## DESIGN REVIEW COMMITTEE

March 7, 2019

SUBJECT: Design Review Request (DR 18-02) by Thomas Buckingham, Buckingham Resources, to construct a single-family dwelling at 2880 Mill Pond Lane

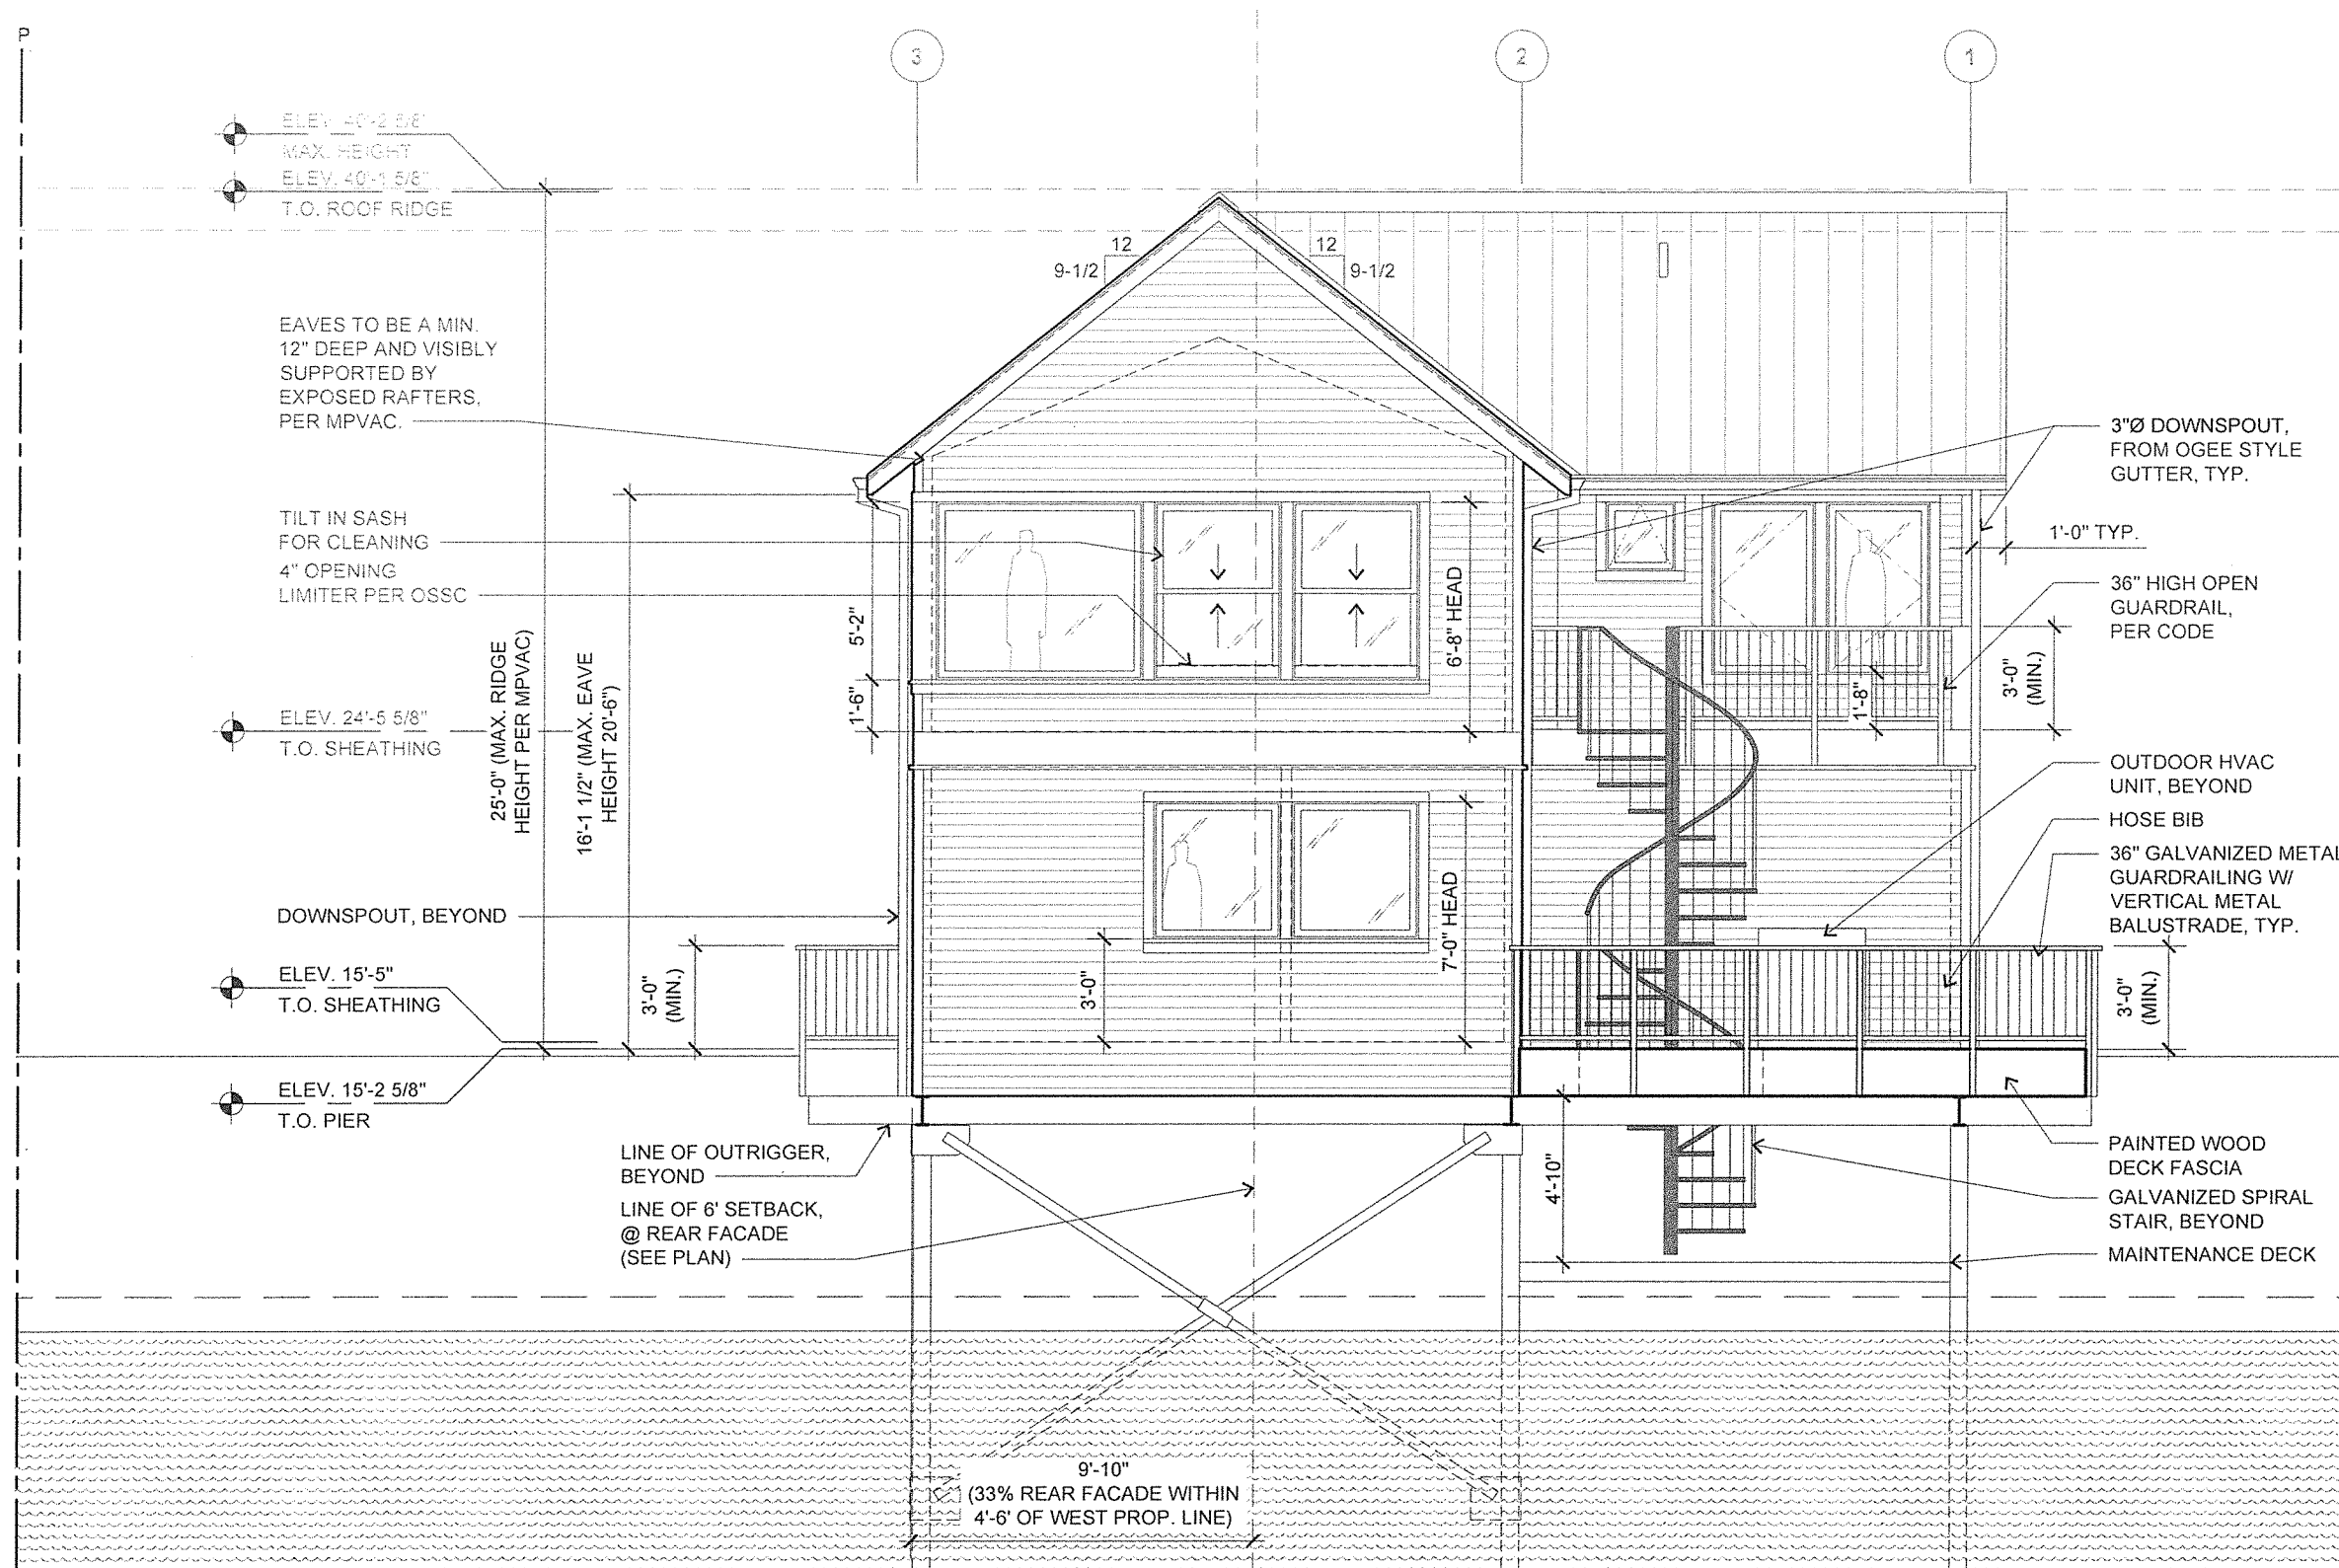
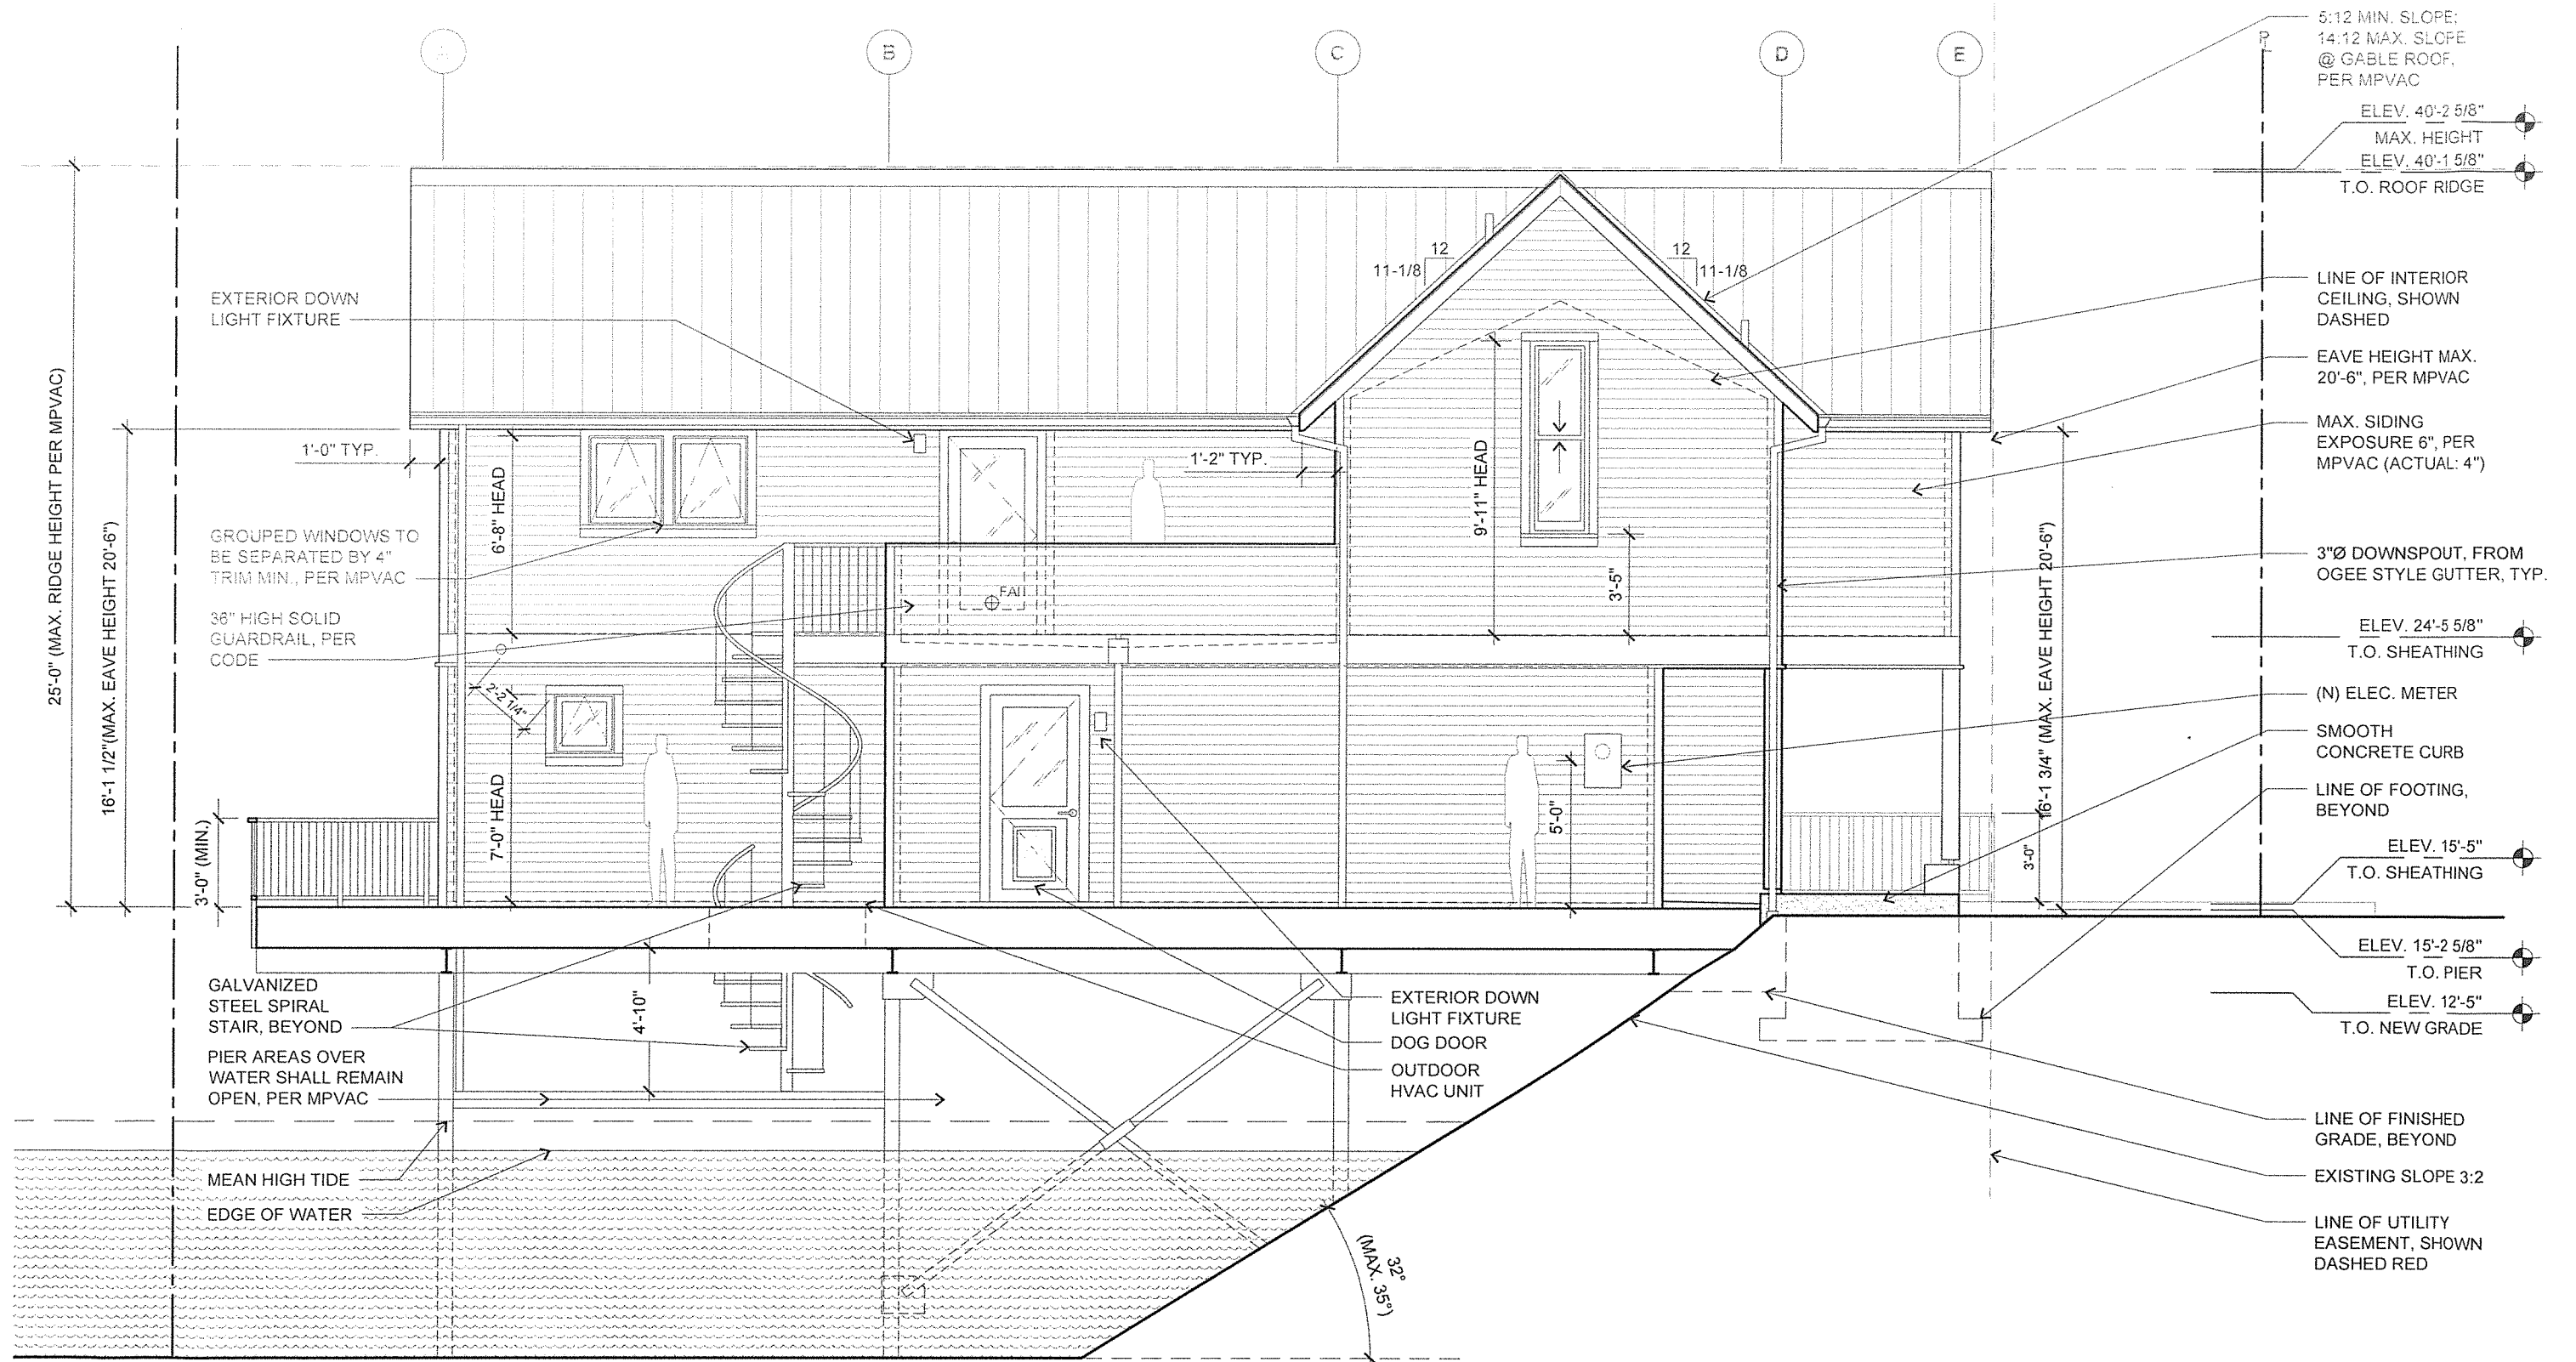
**Comment #2: Windows need muntin grids, per drawing 4a on page 20 of the MPVAC.**

Figures 4a and 4b (shown above) diagram allowable versus unallowable shutter dimensions. A caption, placed directly below the diagram, states: “door and window shutters shall be sized to cover the complete opening (Figures 4a and 4b)”. Figure 4a is solely used to indicate that any shutters, when closed, must completely cover the window. Figure 4b indicates shutters too small to cover the window.

Window configuration is not at issue in either diagram. Bulletpoint #2 on page 20 of the MPVAC states: “no single lite or pane of glass visible from the street shall be greater than 24 square feet in area”. This rule does not prohibit single lite-windows (windows without muntins). Rather, it explicitly allows the use of single-lite windows provided that they comply with square footage requirements along the street facade. Documents provided to the Design Review Board have noted that all street-facing single-lite windows comply with this rule (see sheet A.6).
